ONE NORTH WALL QUAY

An Bord Pleanála - 1<sup>st</sup> Party Appeal Submission

Dublin City Council Reg. Ref: 3274/24

10.05.2024

### Proposed design modifications to refused design:

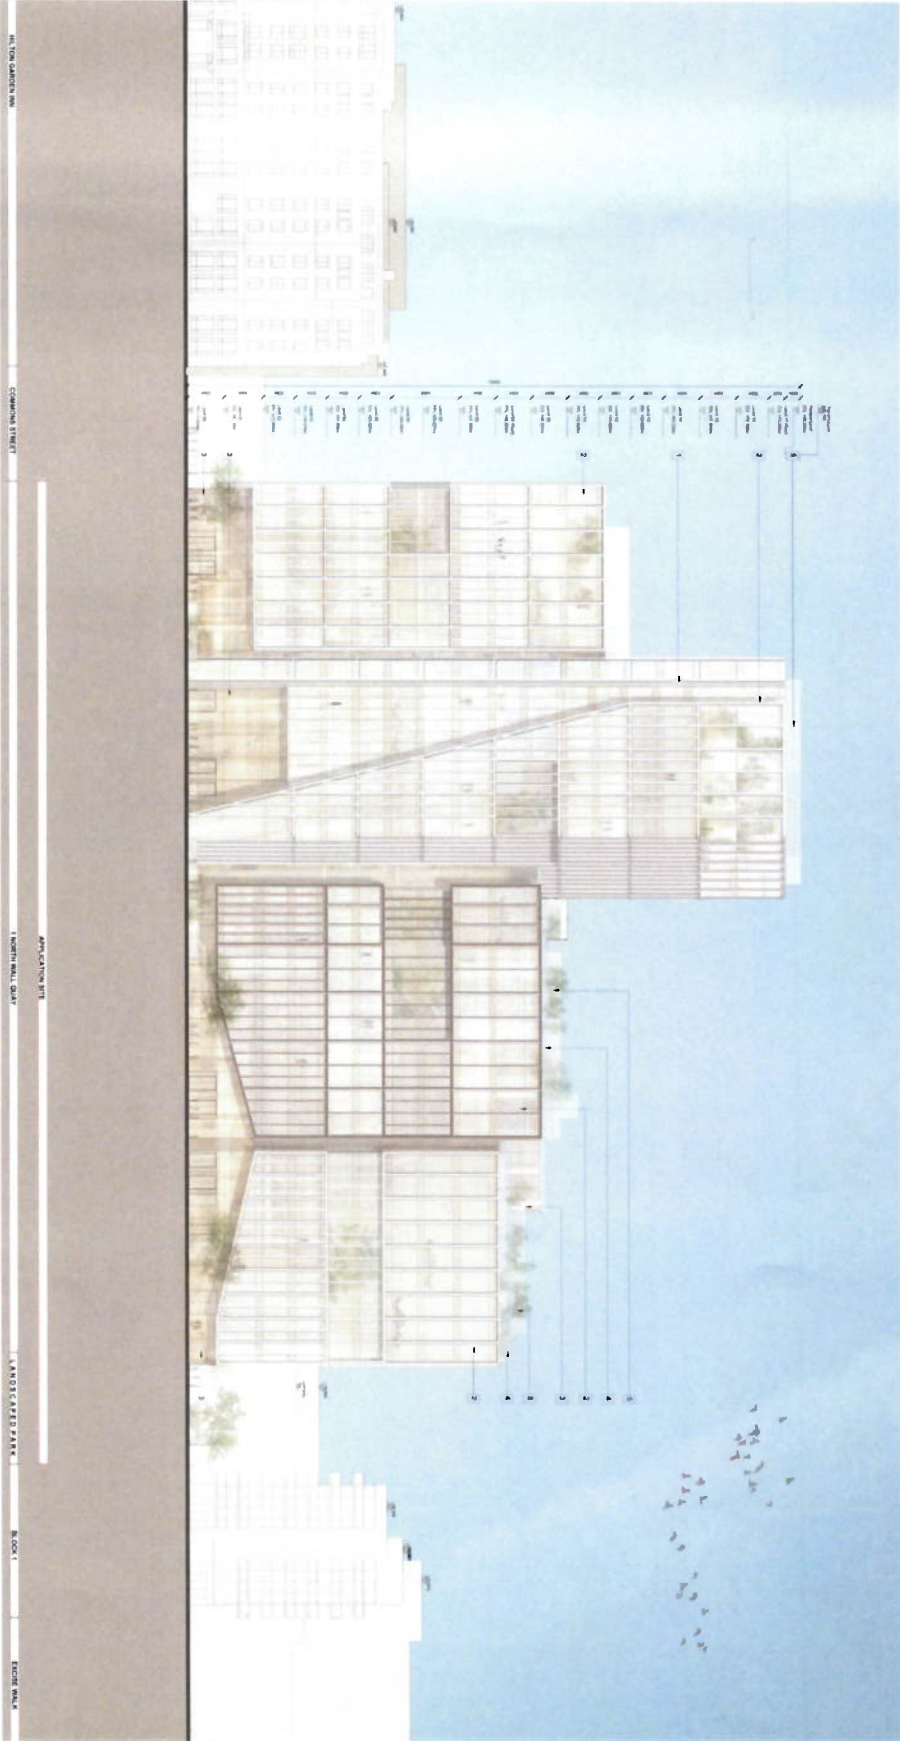
Building footprint reduced on levels 06, 07 & 08 to allow increased facade setbacks and reduced parapet height at the building's eastern end to provide a stepped height transition to the neighbouring buildings.

*(note: outline of original application design shown in dashed red line)*

South Elevation (Partial): **Original Application\_Refused by DCC.**

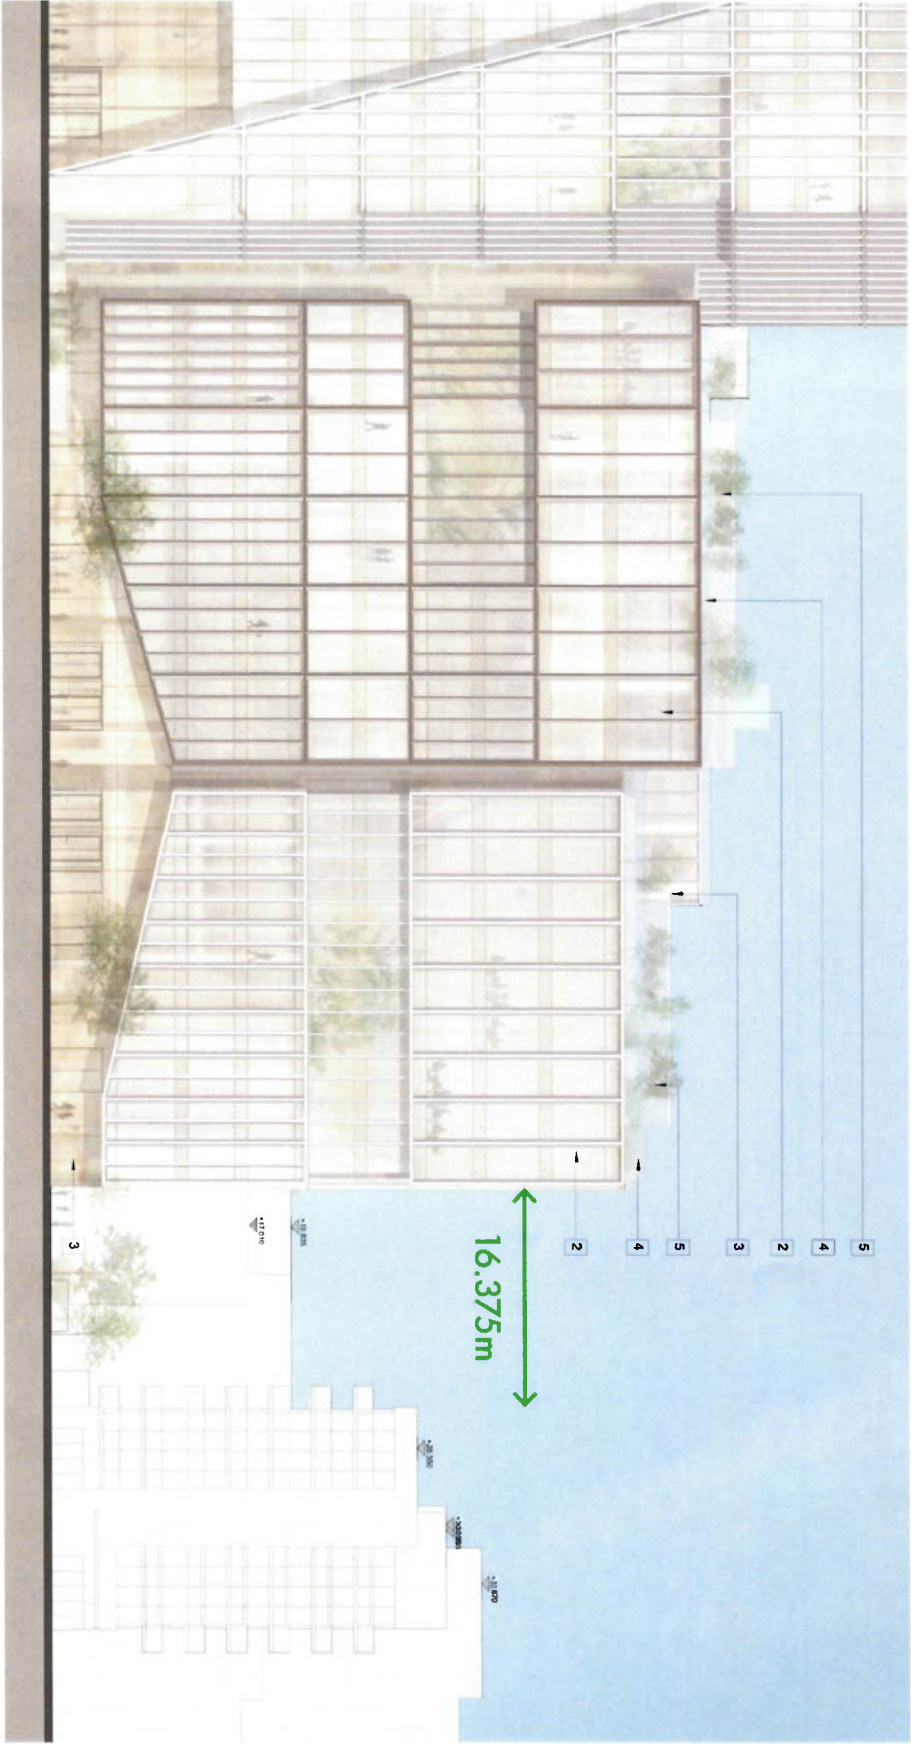
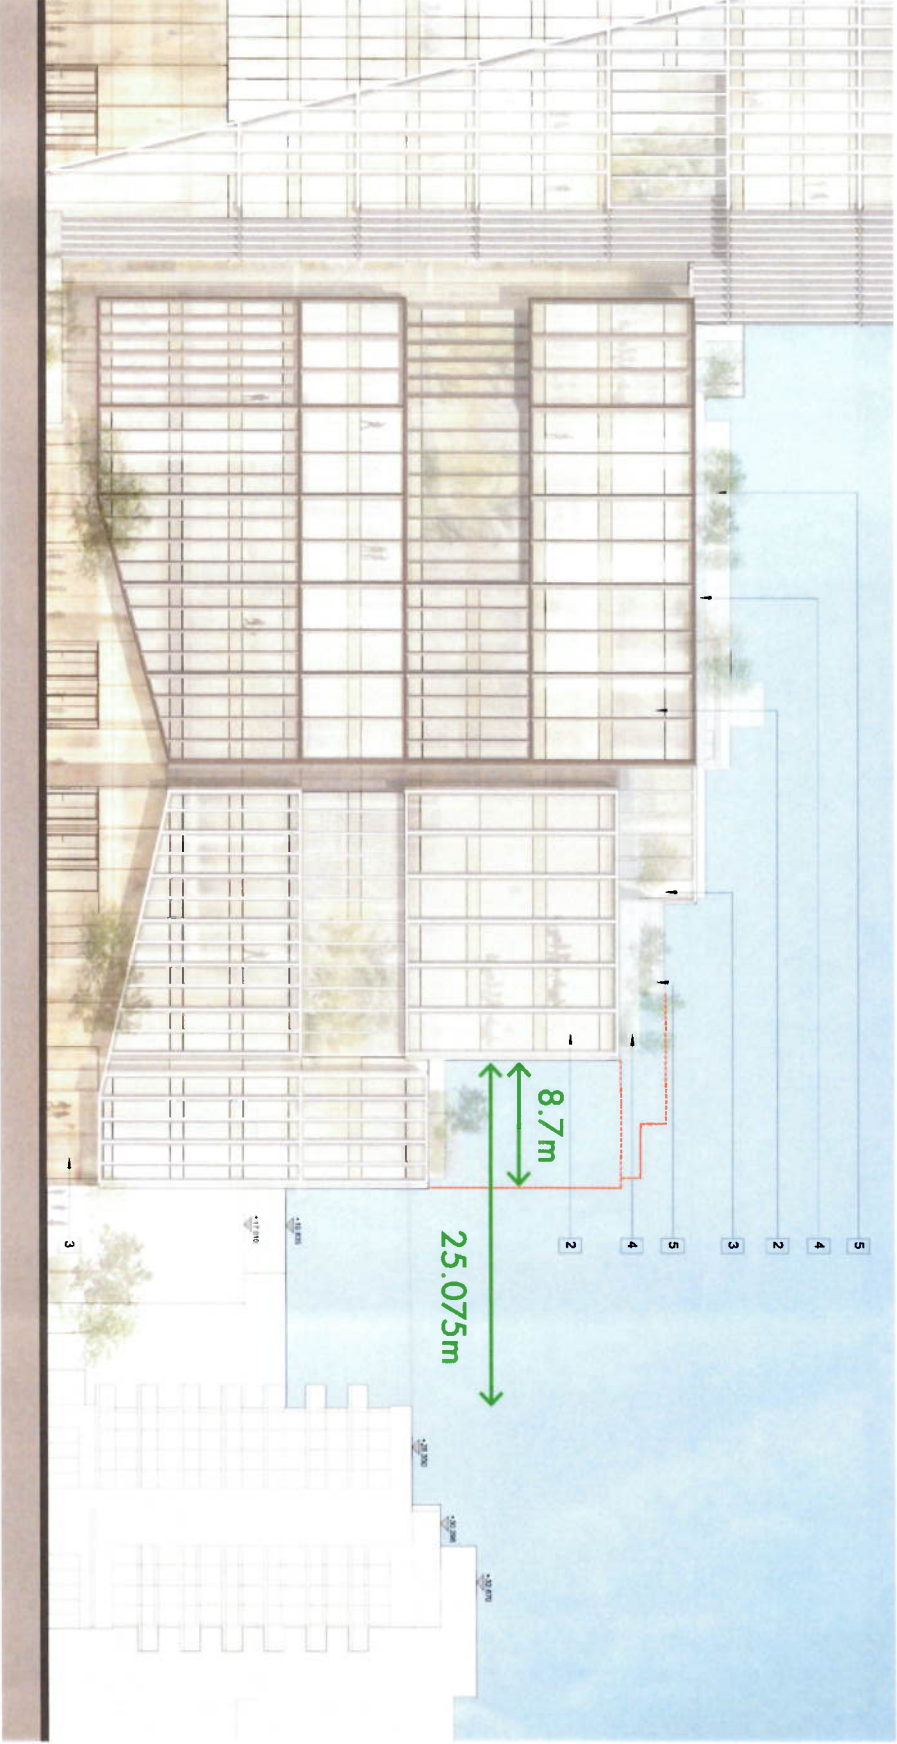
Building footprint reduced on levels 06, 07 & 08 to allow increased facade setbacks and reduced parapet height at the building's eastern end to provide a stepped height transition to the neighbouring buildings.

*(note: outline of original application design shown in dashed red line)*

**Partial Section CC (Drawing 0302): Drawing not submitted as part of original planning application, however design remains unchanged.**

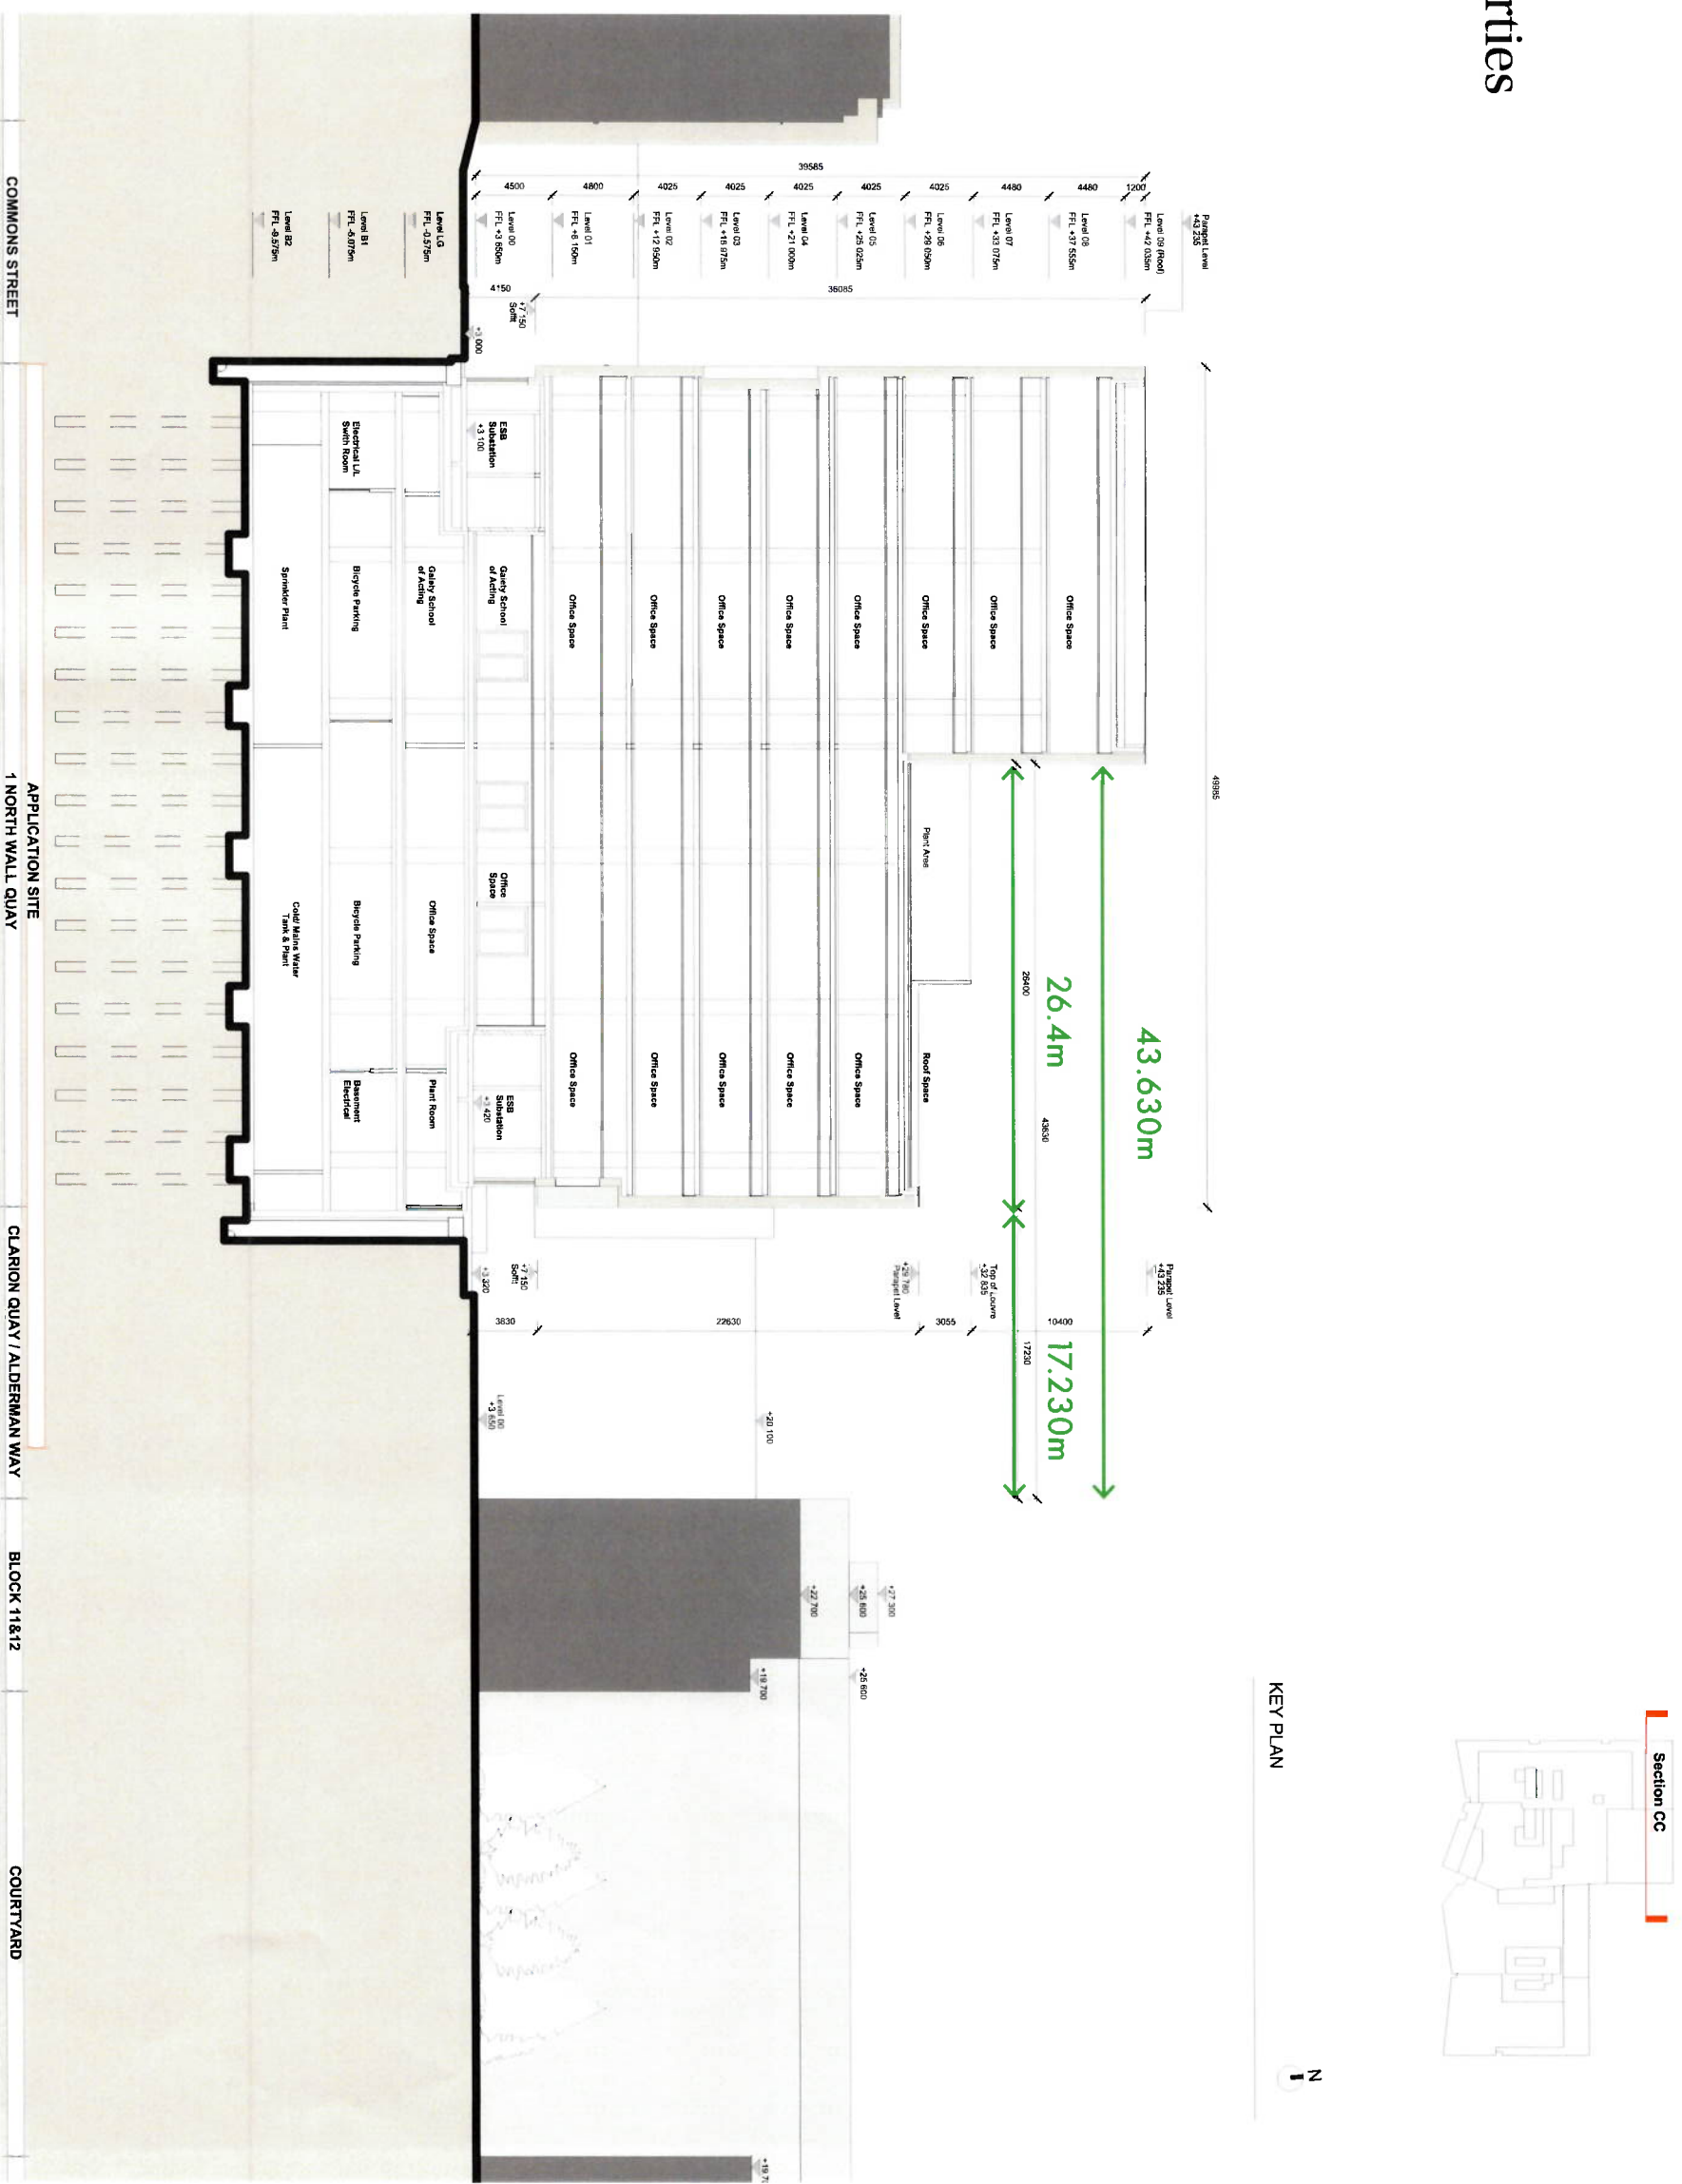
*"Similarly, the proposal is also likely to have an overbearing impact on the residential blocks to the rear given their proximity to the boundary of the site separated only by a laneway. In particular, the Clarion Quay Apartments are likely to be significantly negatively impacted due to the fact that the proposed build elements B and C to a certain extent wrap around the western block (Block 12) affecting both sides of the block.*

It is noted that the Section drawings submitted are limited and do not clearly show the impact of the missing of the proposal on the Clarion Quay Apartments.

Due to the proximity of the new building to the residential blocks, and limited separation distance provided only by a laneway, the overbearing impacts are likely to be considerable."

The appellant submits that the scheme as submitted is appropriate for the context of the application site. The additional section drawing demonstrates that the original design has responded sensitively to its proximity to neighbouring properties by significantly reducing the massing of the building along the Clarion Quay boundary interface.

A large facade set-back is incorporated into the design to create an appropriate parapet height along Clarion Quay and mitigate the perceived overbearing impact along with sunlight & daylight impact upon the neighbouring residential properties.
